SECTION 009113 – ADDENDUM TWO

Project Name: 22045 Amite County Elementary School Parking
Lot & Site Development

- A. Owner: Amite County School District, 533 Maggie Street, Liberty, MS 39645A
- B. Architect: Bailey Architecture Education, P.A., 201 Park Court, Suite B, Ridgeland, MS 39157
- C. Architect Project Number: 22045
- D. Date of Addendum Two: 23 February 2023

SET/SHT
C-101
 CIVIL DEMOLITION PLAN

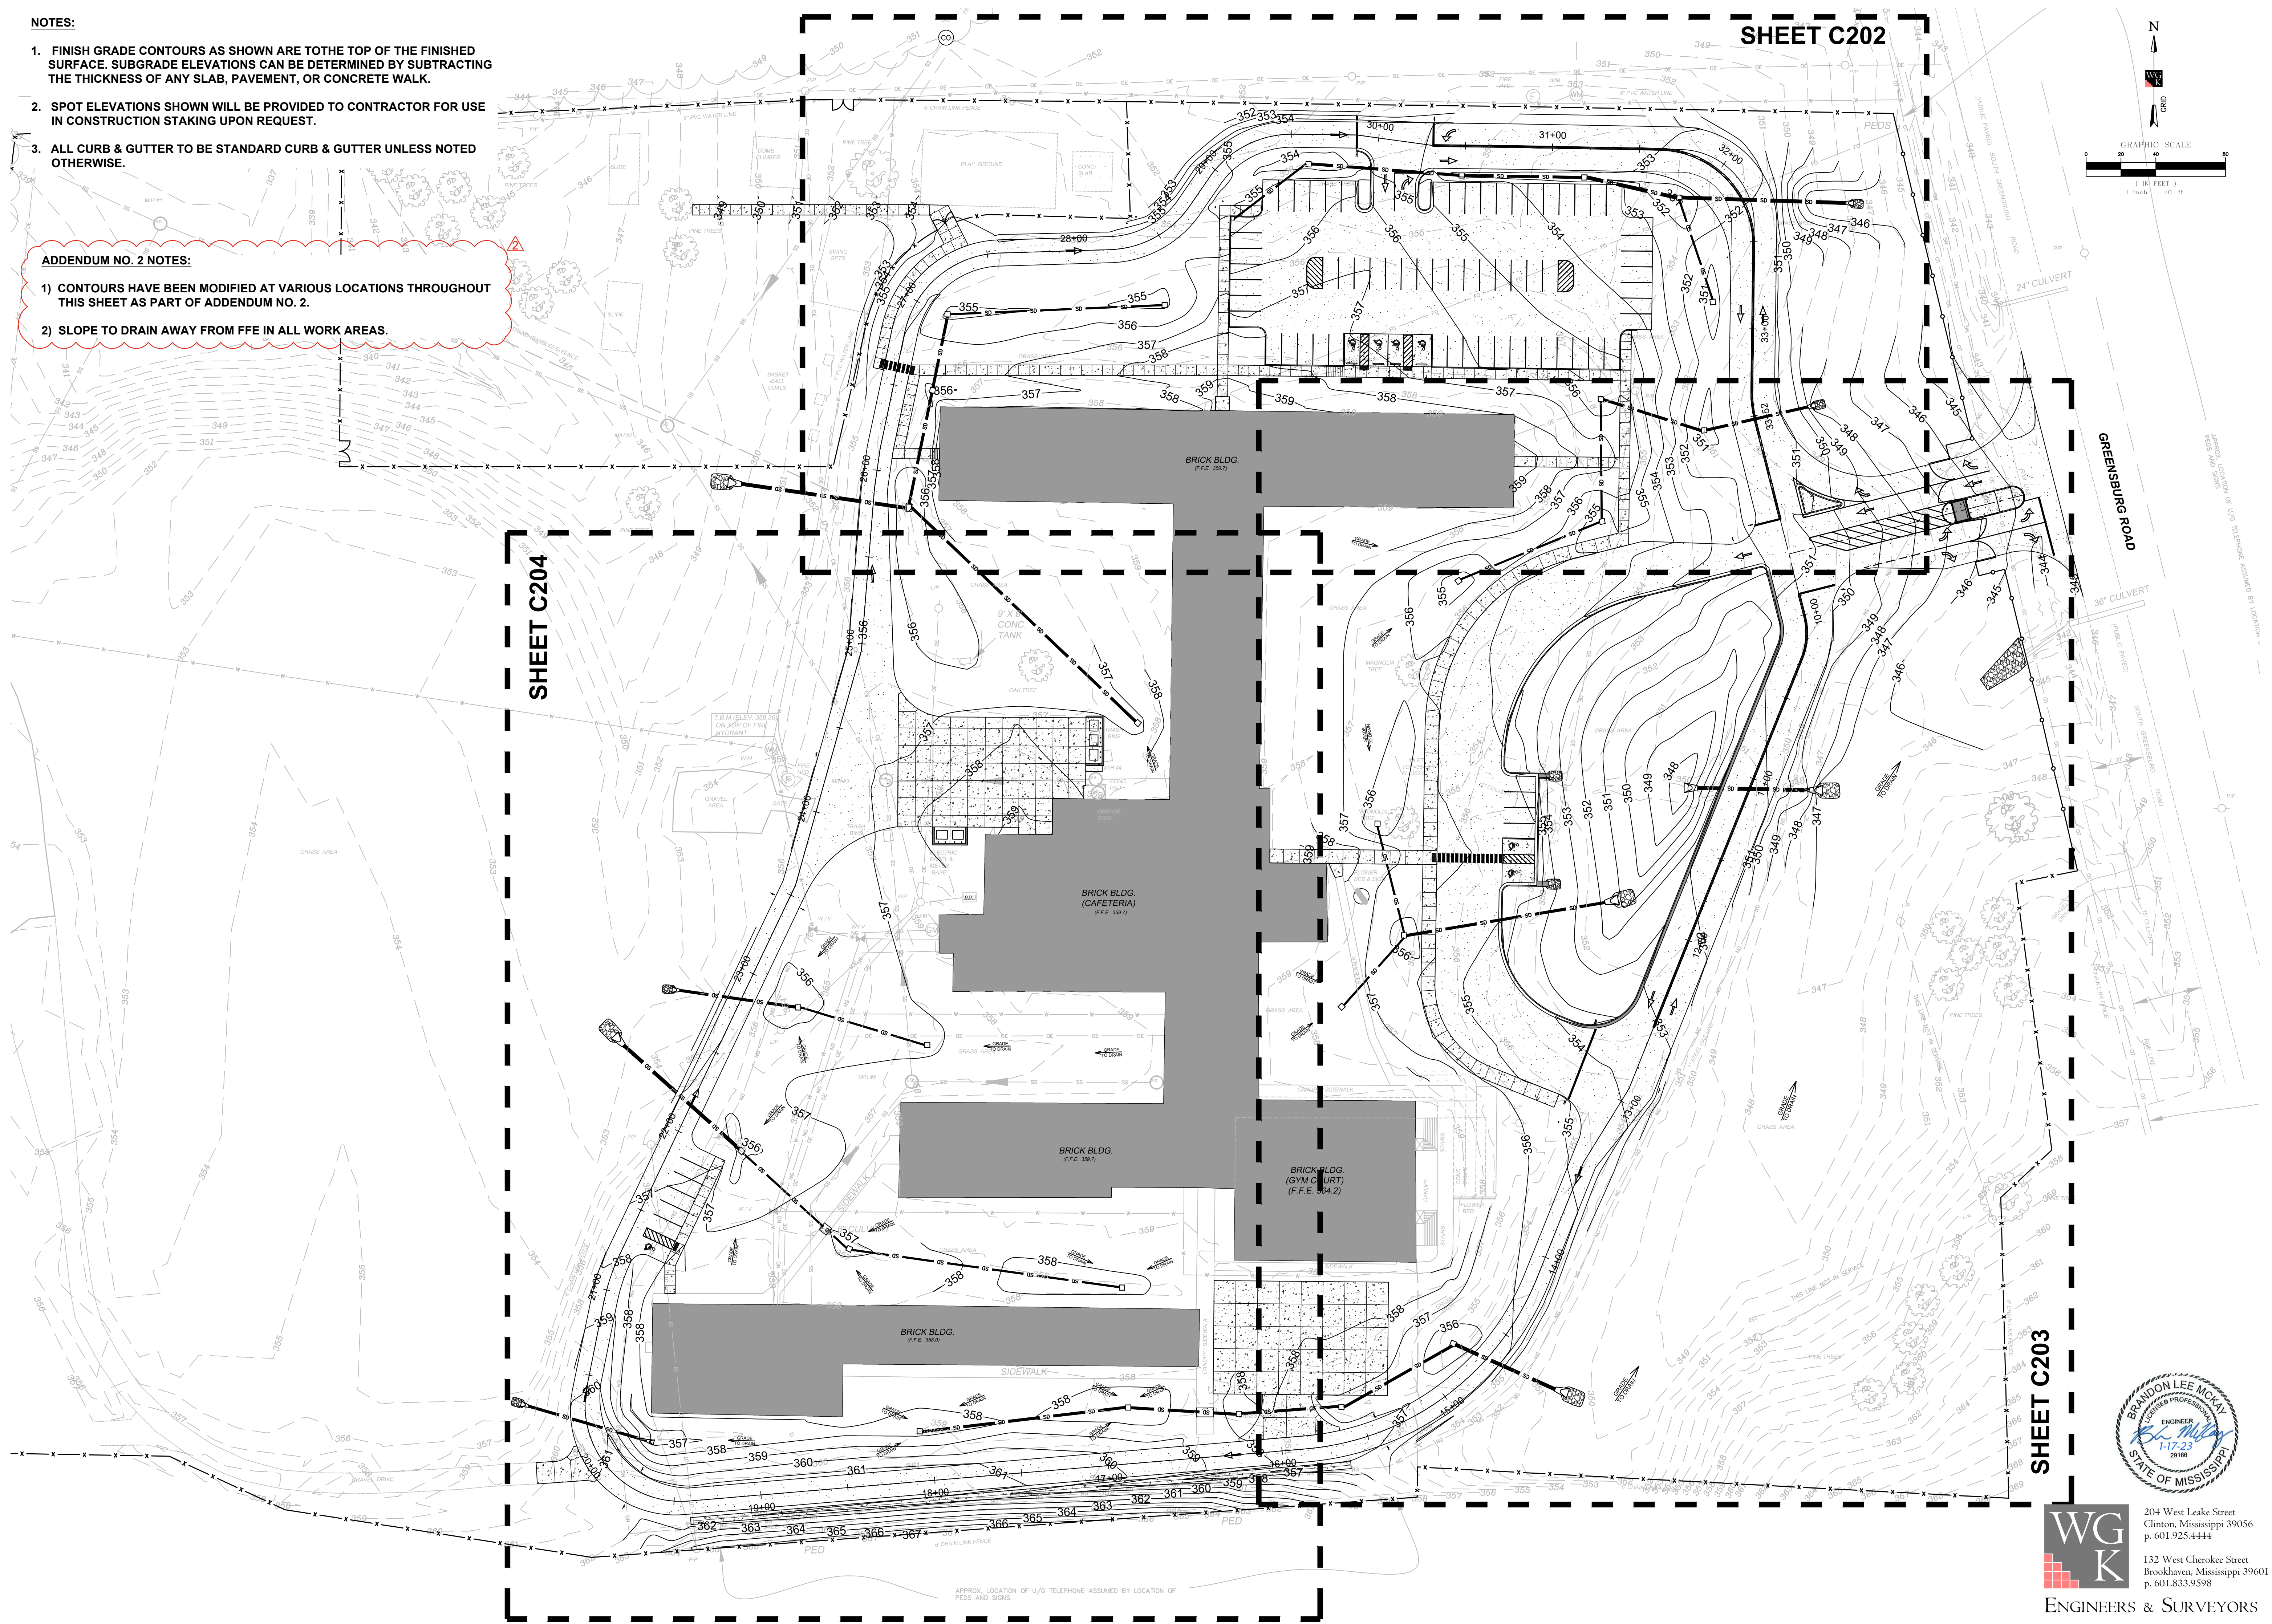
- A. Sheet AS101 – ARCHITECTURAL SITE PLAN, NO. 2 GUARDHOUSE – NEW CONSTRUCTION. (Not Reissued). Change slab dimensions to read 12'-4" x 8'-8".
- B. Sheet C-101 – CIVIL DEMOLITION PLAN. Added sidewalk demolition and revised fence removal. See attached.
- C. Sheet C-201 – GRADING & DRAINAGE PLAN -- OVERVIEW. Added notes and revised contours throughout. See attached.
- D. Sheet C-202 – GRADING & DRAINAGE PLAN – NORTH LOT. Added notes, Inlet #1A, and modified pipe lengths and inverts as needed. Also added spot elevations and revised contours throughout. See attached.
- E. Sheet C-203 – GRADING & DRAINAGE PLAN – EAST LOT. Added notes, spot elevations, and revised contours throughout. See attached.

SET/SHT
C-201
 GRADING & DRAINAGE
 PLAN - OVERVIEW

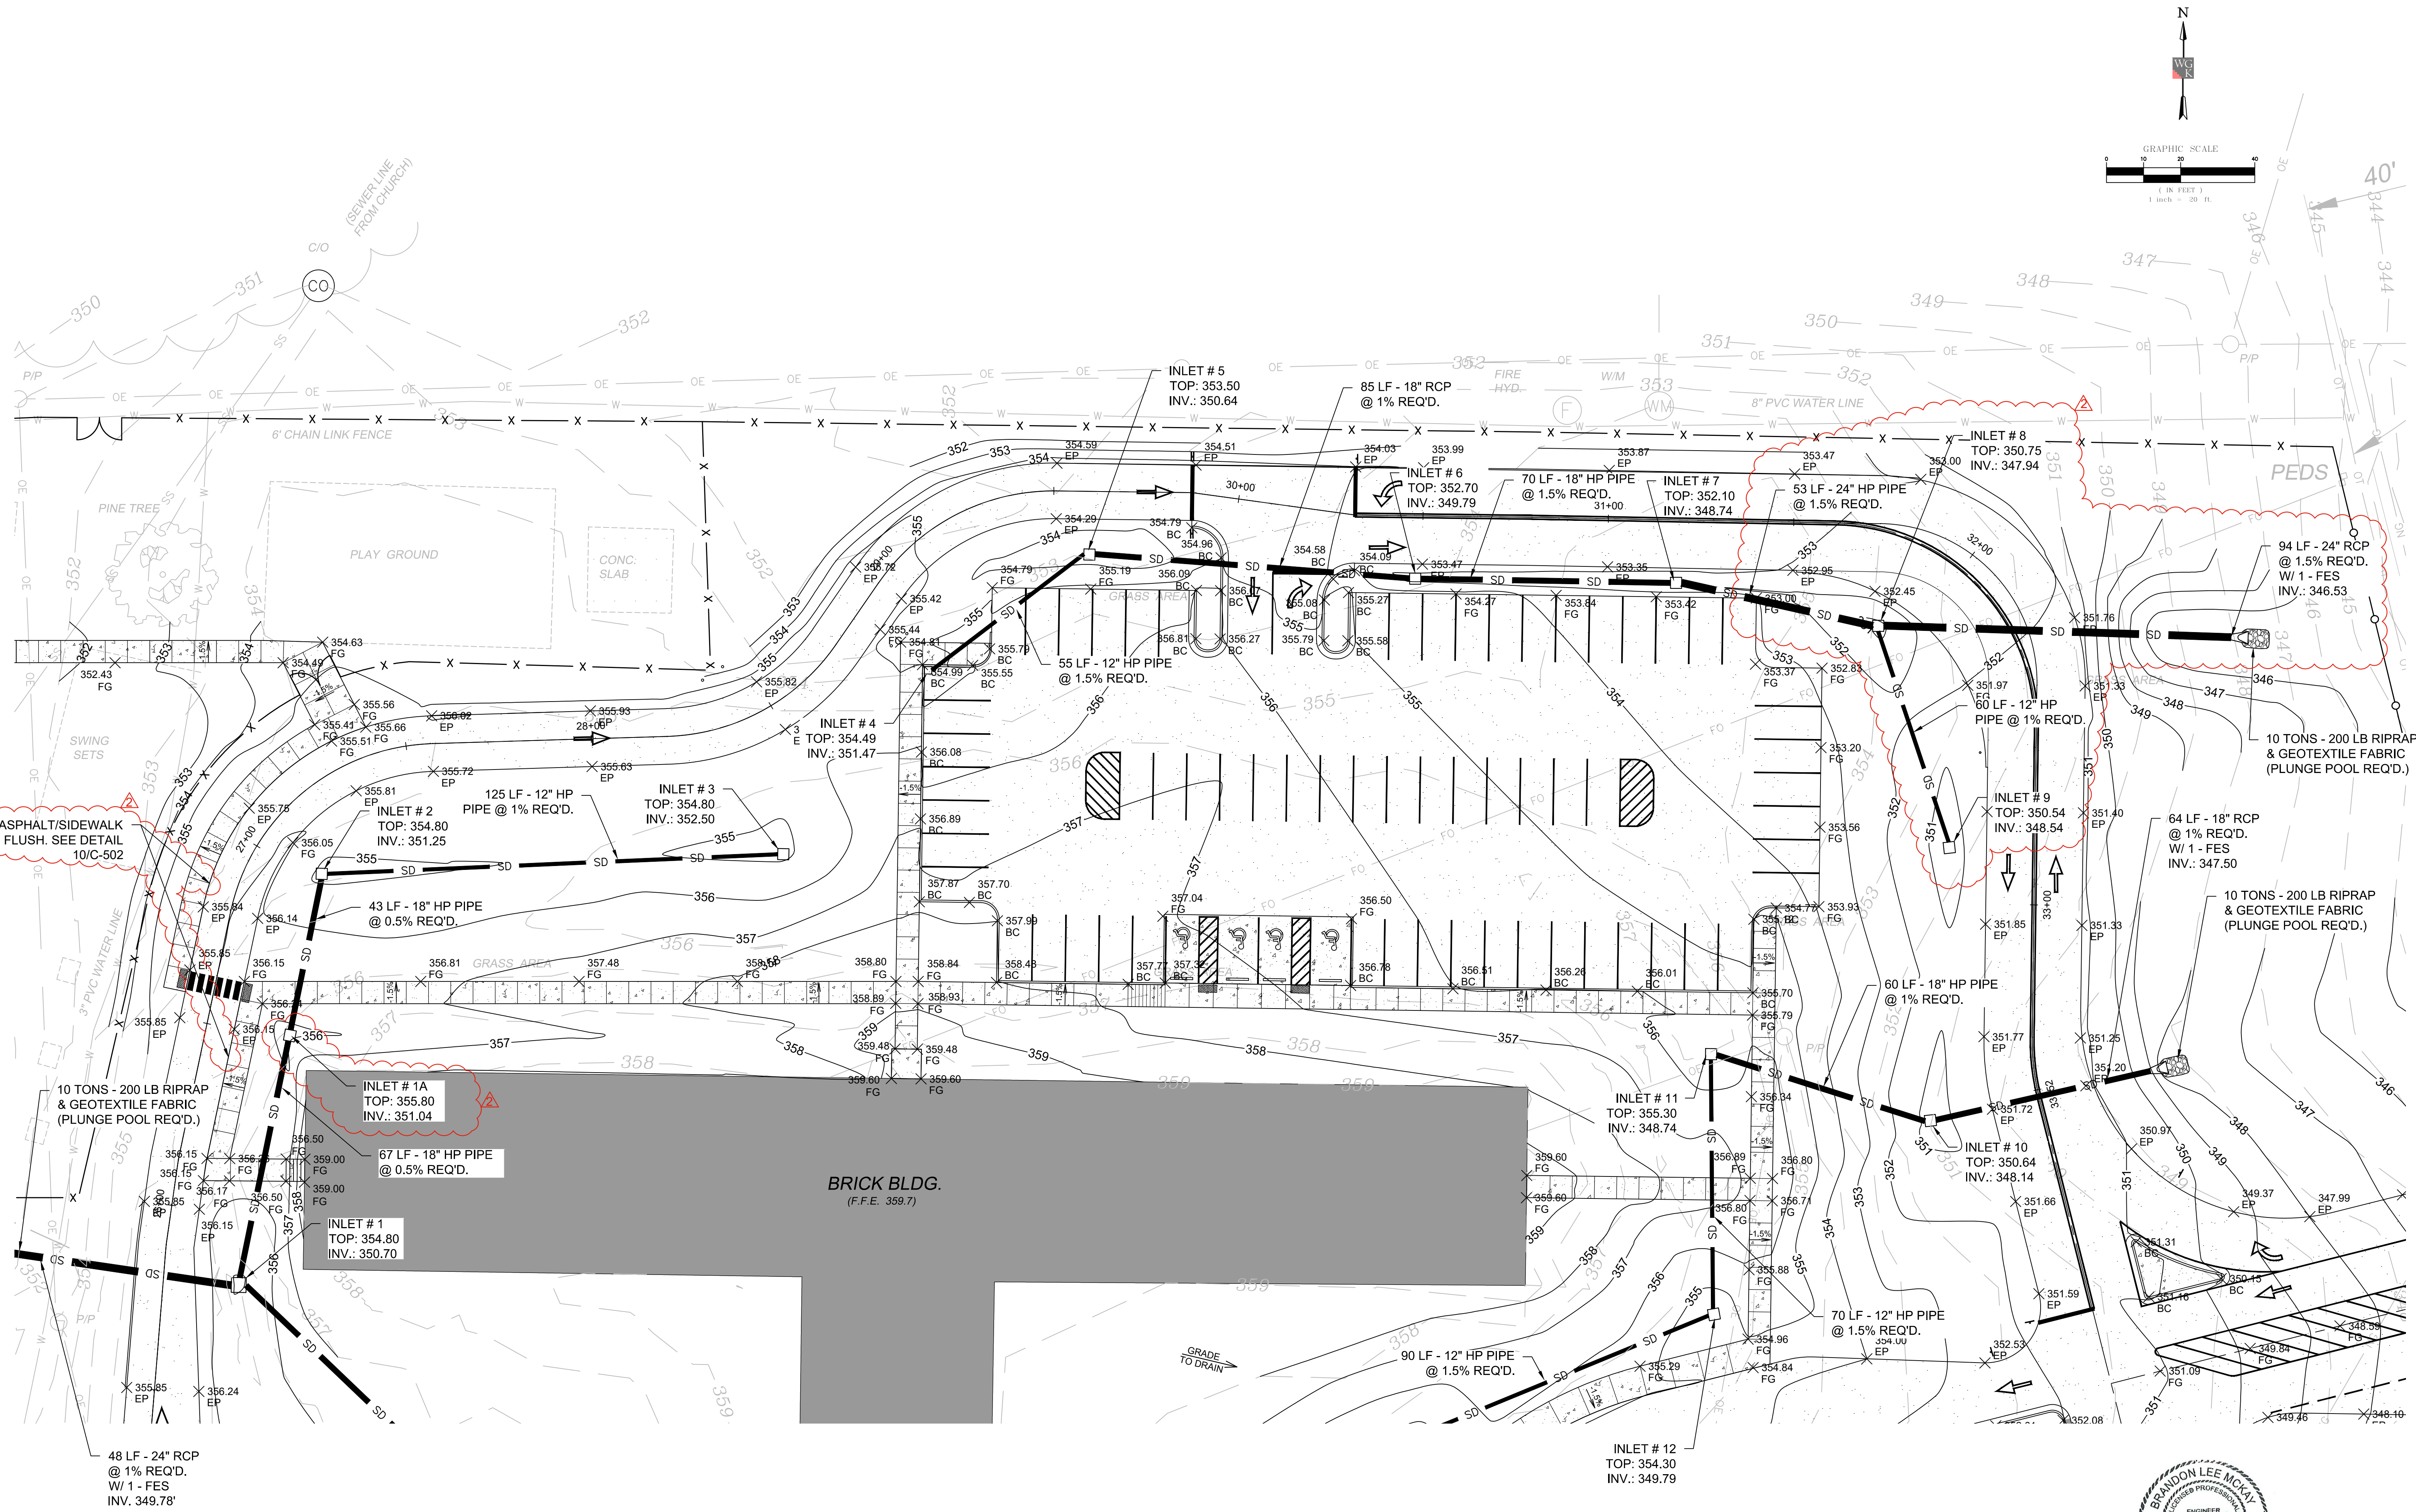
KK. QUESTION: The 24" RCP on Sheet C-202 (48LF) is not shown all the way to outlet. On Sheet C-201 is scales to 96LF.

ANSWER: The scaled dimension of 96 LF is correct instead of the 48 LF that is shown in the annotation.
